21G-04-0031
GOV-01-55-04
ACF-04-0045

April 5, 2004

**Subject: License Amendment Request to Remove Sampling Requirements
for Banner Spring Branch**

Attachment
Page Changes to SNM-124

FIGURE 13.1
SITE GROUNDWATER MONITORING WELL LOCATIONS

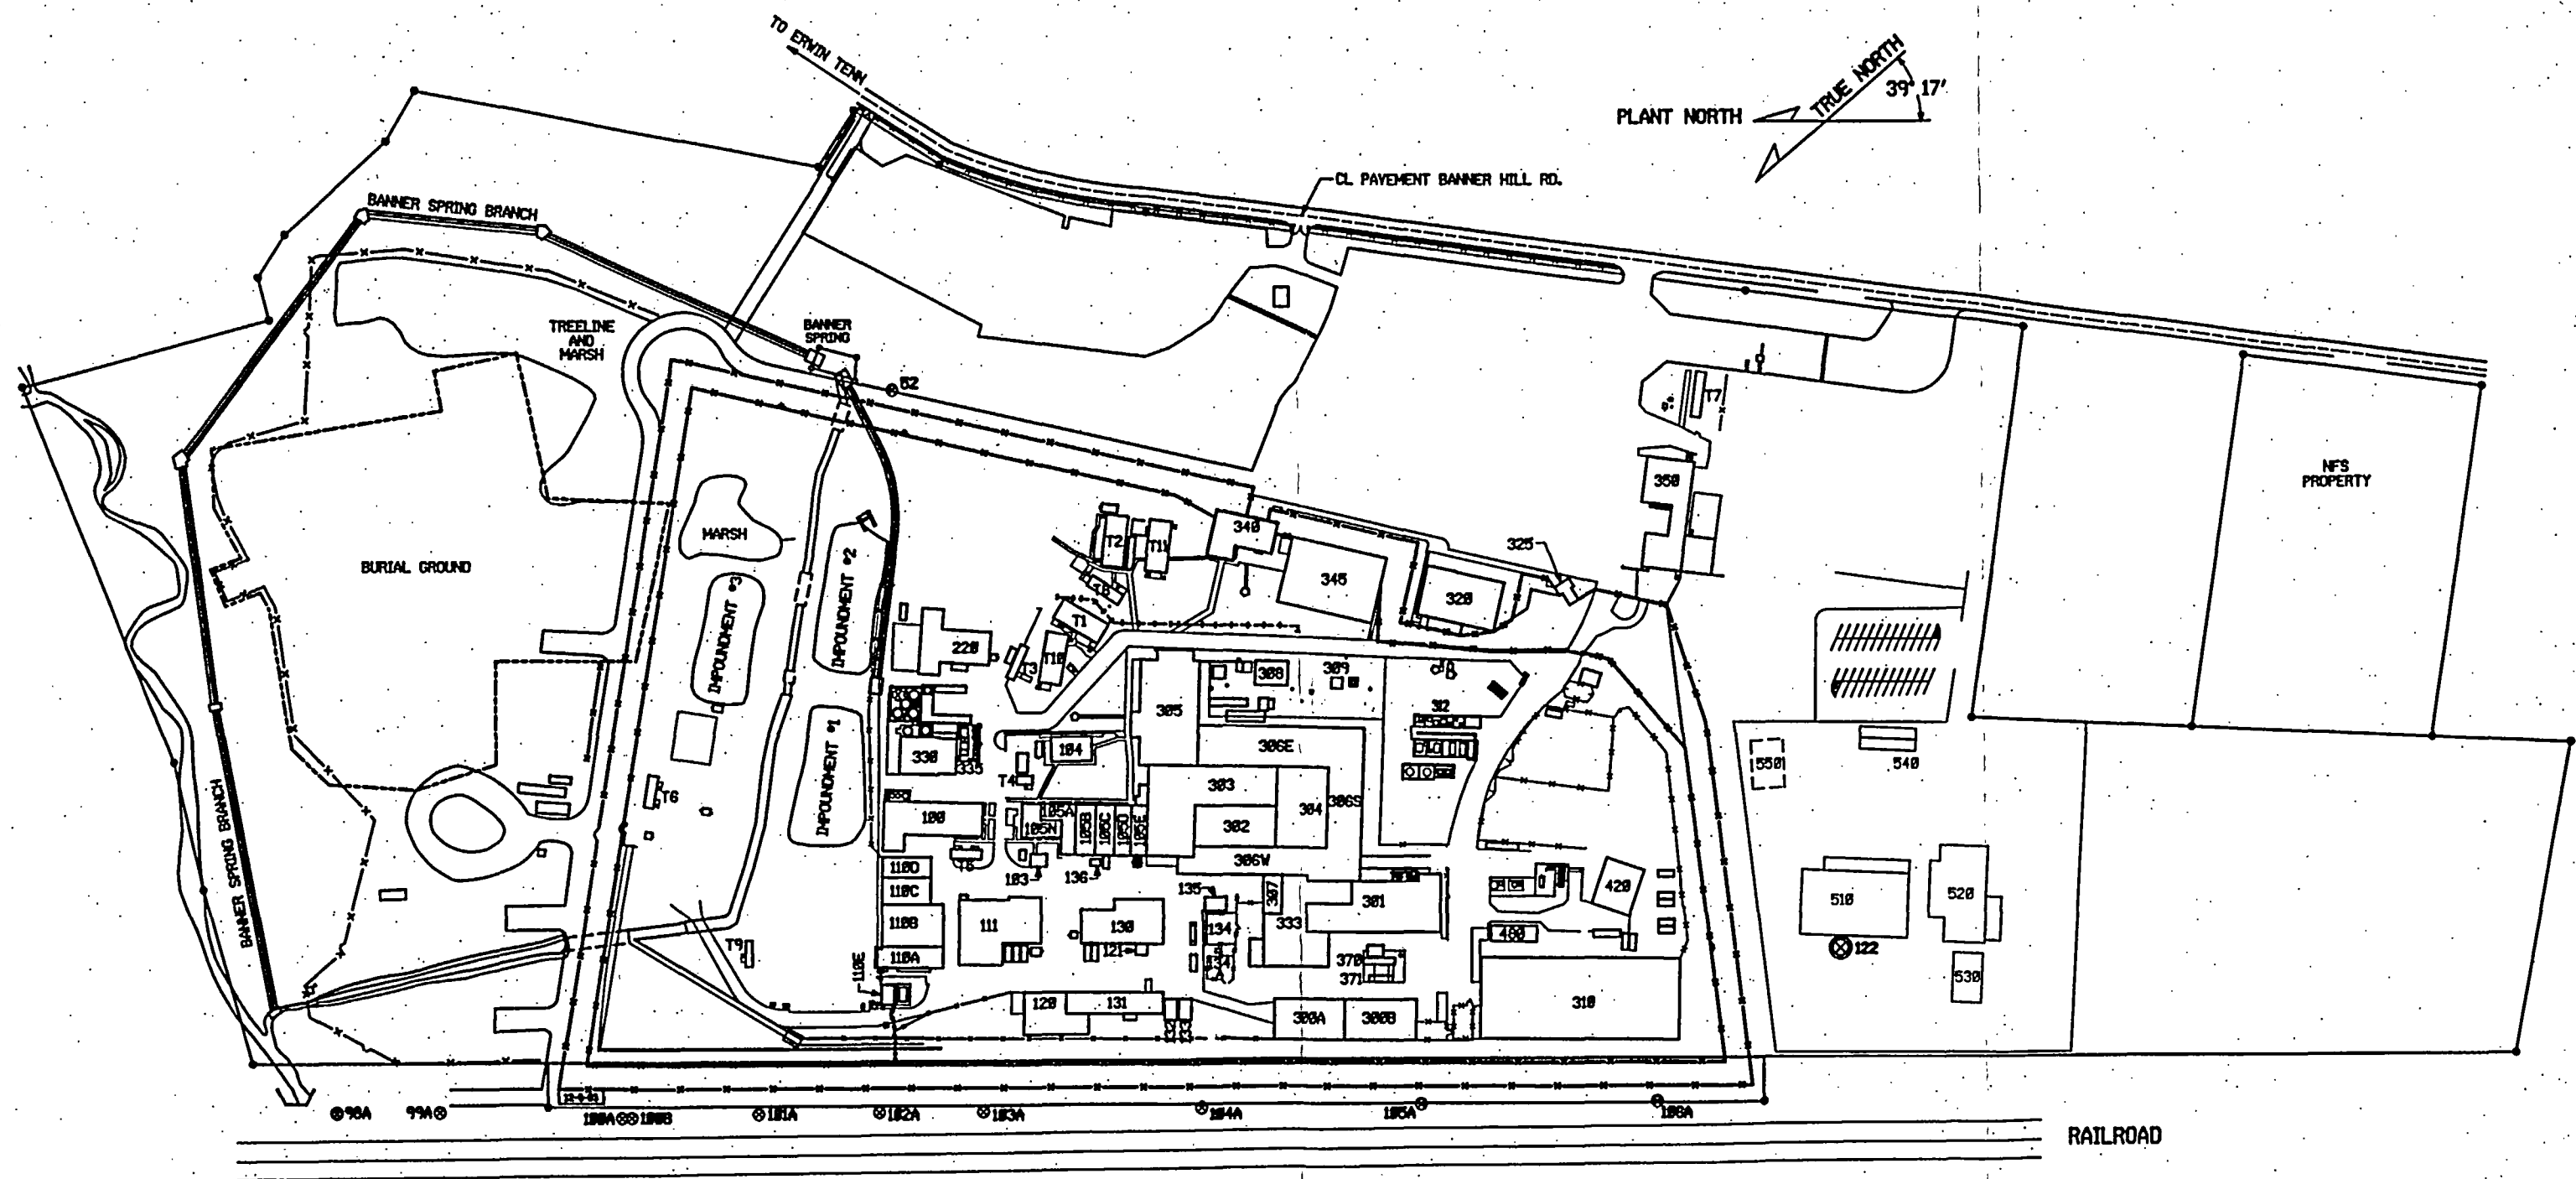
TOLERANCE UNLESS SPECIFIED		NFS		NUCLEAR FUEL SERVICES, INC. EVAN, TENNESSEE	
ADDED NEW LOCATION OF BANNER SPRING BRANCH		A		SNM-124 GROUNDWATER MONITORING PROGRAM MONITORING WELL LOCATIONS	
BY	DATE	REVISION	LET	DECIMAL	DRAWN
BY	DATE	REVISION	LET	DECIMAL	DRAWN
THIS DRAWING, INCLUDING ALL INFORMATION CONTAINED HEREIN, IS THE PROPERTY OF NUCLEAR FUEL SERVICES, INC. AND IS NOT TO BE COPIED, REPRODUCED, OR TRANSMITTED IN ANY FORM OR BY ANY MEANS, WITHOUT PRIOR WRITTEN CONSENT OF NFS.				SCALE 1"=200'	
DATE 02-19-02				DATE 02-20-04	
ORIGINAL ISSUE				005-C0132-B1	
REVISION				CONFIRMATION CONTROL YES	
LET				NO
